UNITED STATES PATENT AND TRADEMARK OFFICE

APPLICATION NO.	FILING DATE	FIRST NAMED INVENTOR	ATTORNEY DOCKET NO.	CONFIRMATION NO.
10/782,961	02/23/2004	Shinya Marushima		7569

Office Action Summary

DETAILED ACTION***Drawings***

Fig. 4B**Fig. 4C**

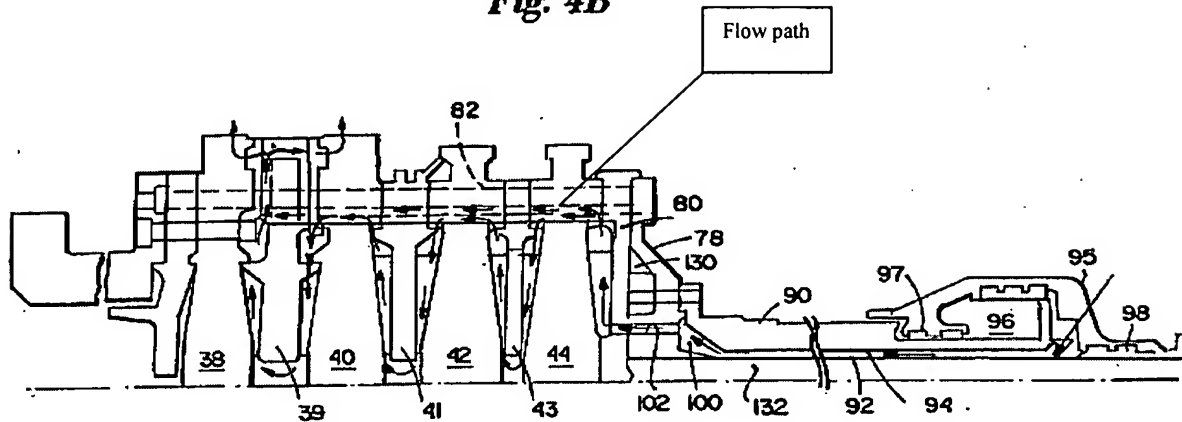
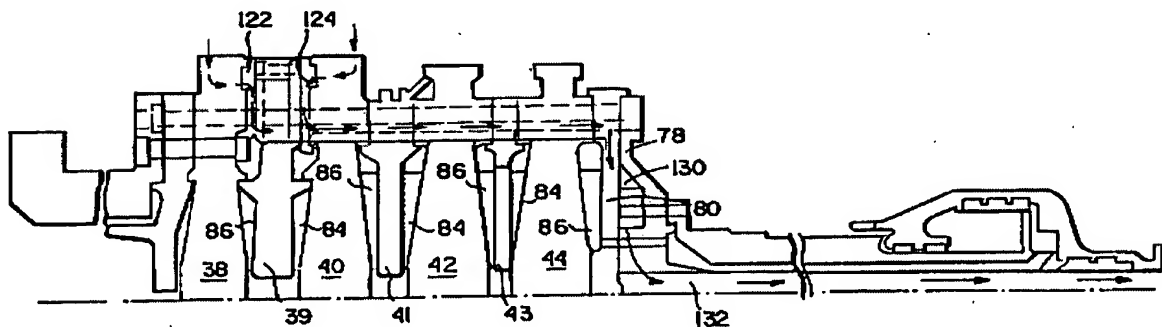
With respect to claim 11, Carreno teaches a gas turbine which a rotor shaft comprises a plurality of discs 38, 40, 42, 44 each having a plurality of moving blades arranged annularly on the peripheral portion, and spacers 39, 41, 43 arranged between said discs, said respective discs 38, 40, 42, 44 and spacers being arranged in an axial direction in turn, comprising: gap portions 84, 86 formed between rotor axis side regions of said discs 38, 40, 42, 44 facing said spacers 39, 41, 43 and adjacent spacers; a supply flow path 92 for supplying refrigerant for cooling to said moving blades and a recovery flow path 132 for recovering heated refrigerant, each of said

supply and recovery flow paths being provided in said rotor shaft; a flow path (see Figure 4B) for introducing fluid into said gap portions 84, 86, provided in said discs; wherein said recovery flow path 132 is arranged on a more radially inner side than said supply flow path 92. See particularly **Figures 4B, 4C** of Carreno above.

With respect to claim 12, **Carreno** teaches a gas turbine which a rotor shaft comprises a plurality of discs 38, 40, 42, 44 each having a plurality of moving blades arranged annularly on the peripheral portion, and spacers 39, 41, 43 arranged between said discs, said respective discs 38, 40, 42, 44 and spacers being arranged in an axial direction in turn, comprising: gap portions 84, 86 formed between rotor axis side regions of said discs 38, 40, 42, 44 facing said spacers 39, 41, 43 and adjacent spacers; a supply flow path 92 for supplying steam for cooling to said moving blades and a recovery flow path 132 for recovering heated steam, each of said supply and recovery flow paths being provided in said rotor shaft; a flow path (see Figure 4B) for introducing fluid into said gap portions 84, 86, provided in said discs; wherein said recovery flow path 132 is arranged on a more radially inner side than said supply flow path 92. See particularly **Figures 4B, 4C**, and column 1 lines 65-67 of Carreno.

FIG. 25
PRIOR ART

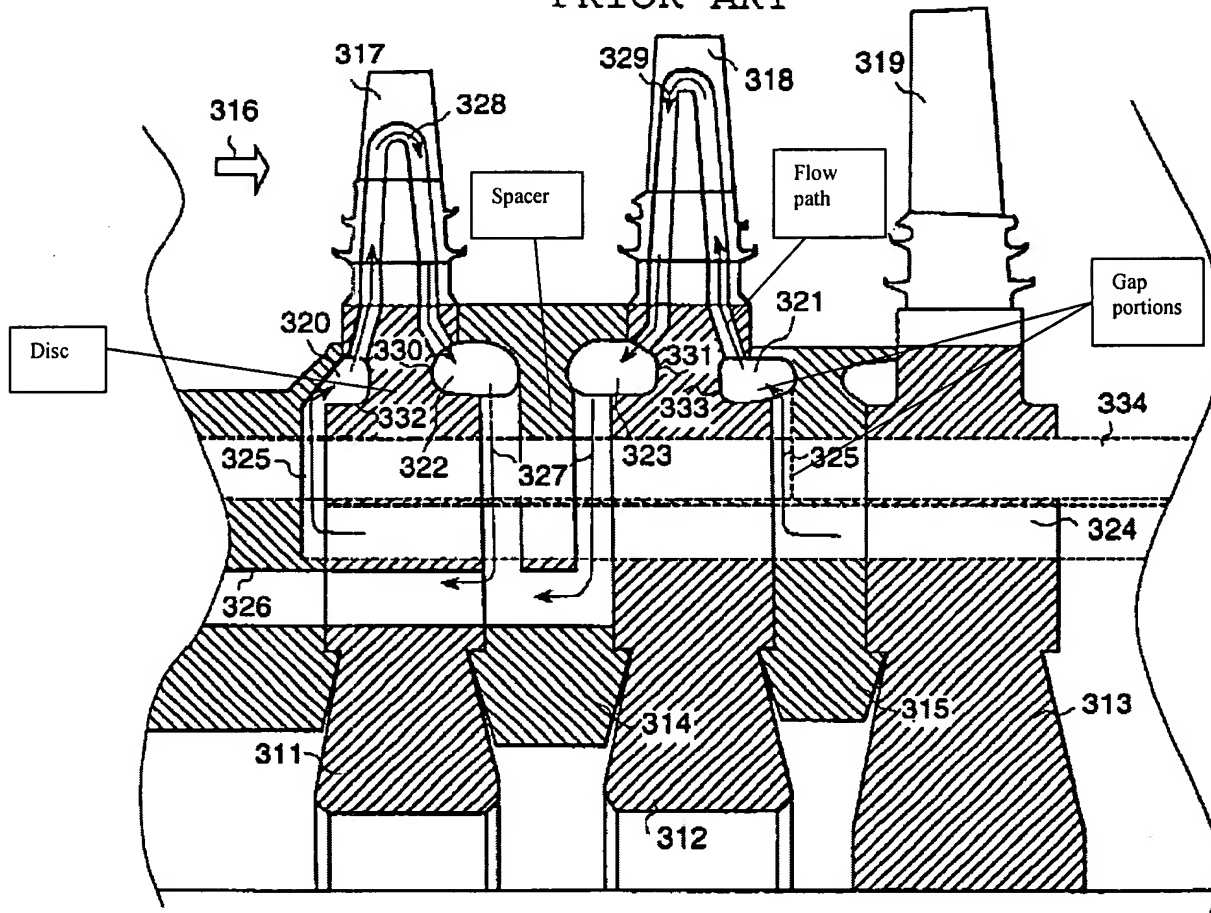
With respect to claim 11, **Akiyama** teaches a gas turbine which a rotor shaft comprises a plurality of discs each having a plurality of moving blades arranged annularly on the peripheral portion, and spacers arranged between said discs, said respective discs and spacers being arranged in an axial direction in turn, comprising: gap portions formed between rotor axis side regions of said discs facing said spacers and adjacent spacers; a supply flow path 324 for supplying refrigerant for cooling to said moving blades and a recovery flow path 326 for

recovering heated refrigerant, each of said supply and recovery flow paths being provided in said rotor shaft; a flow path for introducing fluid into said gap portions provided in said discs; wherein said recovery flow path 326 is arranged on a more radially inner side than said supply flow path 324. See particularly **Figure 25** of **Akiyama** above.

With respect to claim 12, **Akiyama** teaches a gas turbine which a rotor shaft comprises a plurality of discs each having a plurality of moving blades arranged annularly on the peripheral portion, and spacers arranged between said discs, said respective discs and spacers being arranged in an axial direction in turn, comprising: gap portions formed between rotor axis side regions of said discs facing said spacers and adjacent spacers; a supply flow path 324 for supplying steam for cooling to said moving blades and a recovery flow path 326 for recovering heated steam, each of said supply and recovery flow paths being provided in said rotor shaft; a flow path for introducing fluid into said gap portions provided in said discs; wherein said recovery flow path 326 is arranged on a more radially inner side than said supply flow path 324. See particularly **Figure 25**; and column 5 lines 40-46 of **Akiyama**.

With respect to claim 13, **Akiyama** teaches a gas turbine which a rotor shaft comprises a plurality of discs each having a plurality of moving blades arranged annularly on the peripheral portion, and spacers arranged between said discs, said respective discs and spacers being arranged in an axial direction in turn, comprising: gap portions formed between rotor axis side regions of said discs facing said spacers and adjacent spacers; a supply flow path 324 for supplying steam for cooling to said moving blades and a recovery flow path 326 for recovering heated steam, each of said supply and recovery flow paths being provided in said rotor shaft; a flow path for introducing fluid into said gap portions provided in said discs; wherein said flow

path for introducing fluid into said gap portion is constructed so as to be supplied with air extracted from a compressor (column 5 lines 40-46), and said recovery flow path 326 is arranged on a more radially inner side than said supply flow path 324. See particularly **Figure 25**; and column 5 lines 40-46 of **Akiyama**.

Note that **Akiyama** (column 5 lines 40-46) teaches using a combination of air and steam for cooling, just as claimed by the invention in claim 13.
